**SUBDIVISION &  
SIDEWALK WAIVER STAFF REPORT****Date: January 5, 2023****APPLICANT NAME**

Southern Tire Mart Subdivision

**LOCATION**1400 East I-65 Service Road North  
(Northeast corner of East I-65 Service Road North and Georgia Pacific Avenue).**CITY COUNCIL  
DISTRICT**

Subdivision Approval to create one (1) legal lot of record from one (1) existing metes-and-bounds parcel; and Sidewalk Waiver request to waive construction of a sidewalk along East I-65 Service Road North and Georgia Pacific Avenue.

# SITE PLAN

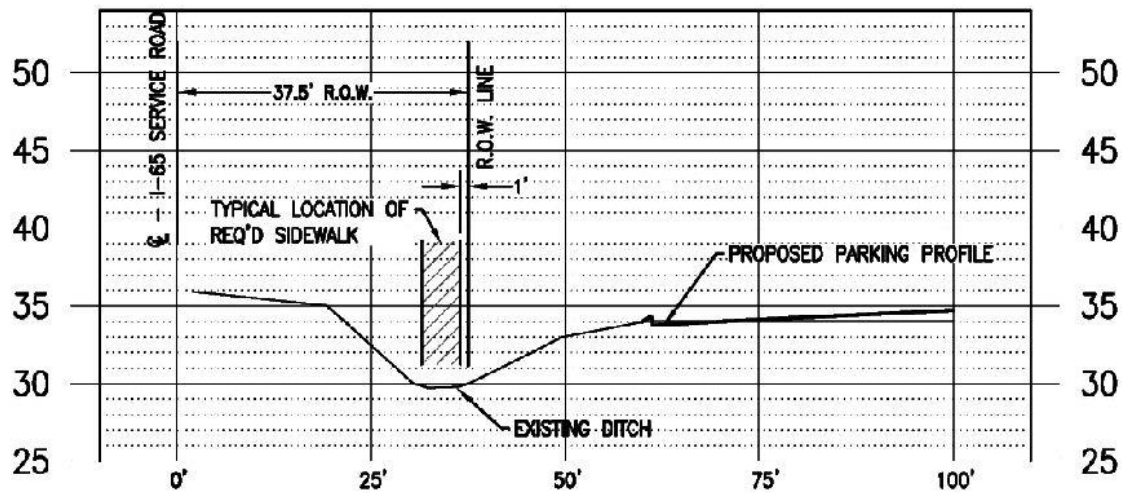
The site has frontage along Interstate Highway 65 and Georgia Pacific Avenue. Interstate 65 is a component of the Major Road Plan with a planned 300-foot right-of-way. The preliminary plat indicates a compliant right-of-way width of 300 feet. Georgia Pacific Avenue is a minor street with curb and gutter and a compliant 50-foot right-of-way. The right-of-way widths of both streets should be retained on the Final Plat, if approved. Dedication should be required to provide a 25-foot radius curve at the intersection of East I-65 Service Road North and Georgia Pacific Avenue, if approved. The plat should also be revised to illustrate the 25-foot minimum building setback line along both street frontages, if approved.

The preliminary plat indicates that the lot meets the minimum size requirements of Section V.D.2. of the Subdivision Regulations. The lot is not labeled with its size on the preliminary plat. Therefore, the plat should be revised to label the lot with its size in both square feet and acres on the Final Plat, if approved, after any required dedication, or a table should be furnished on the Final Plat providing the same information.

The plat indicates an underground sanitary sewer pipe easement along a portion of the Southern boundary of the site. Therefore, a note should be required on the Final Plat stating that no structure shall be constructed or placed within any easement without permission of the easement holder.

- 1) dedication to provide a 25-foot radius curve at the intersection of East I-65 Service Road North and Georgia Pacific Avenue;
- 2) revision of the plat to label the lot with its size in both square feet and acres, after any required dedication, or the furnishing of a table on the Final Plat providing the same information;

- 3) retention of the right-of-way widths of Interstate Highway 65 and Georgia Pacific Avenue on the Final Plat;
- 4) revision of the plat to illustrate a 25' minimum building setback line along all street frontages;

- 5) placement of a note on the Final Plat stating that no structure shall be constructed or placed within any easement without permission of the easement holder;

## SECTION 'A' PROFILE THROUGH RIGHT-OF-WAY

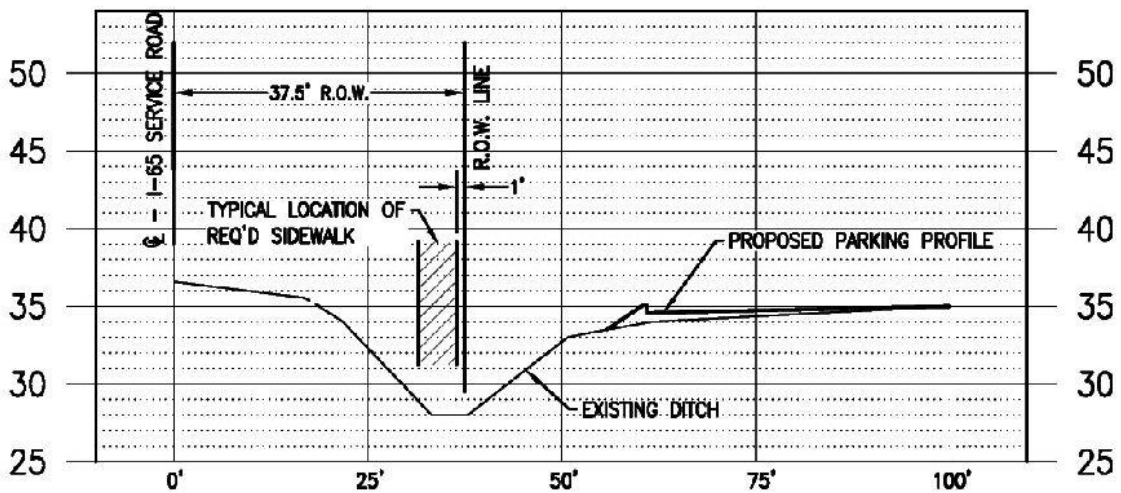
**Sidewalk Waiver:** The area is located within the ALDOT right-of-way and runs parallel to an existing, wide drainage ditch that is partially located within the property. Any sidewalk will have to be constructed inside of the private property and would have to be constructed over a 50 ft wide drainage ditch on the north side.

- 1) *The standard location of the required sidewalk (1' inside of R.O.W. line) would have the sidewalk being in the existing roadside ditch.*
- 2) *There are no existing sidewalks on either side of the site and the area is not considered to be an area where pedestrian traffic is expected.*

**Sidewalk Waiver:** Based upon the preceding, the application to waive sidewalk construction along East I-65 Service Road North and Georgia Pacific Avenue is recommended for Approval.
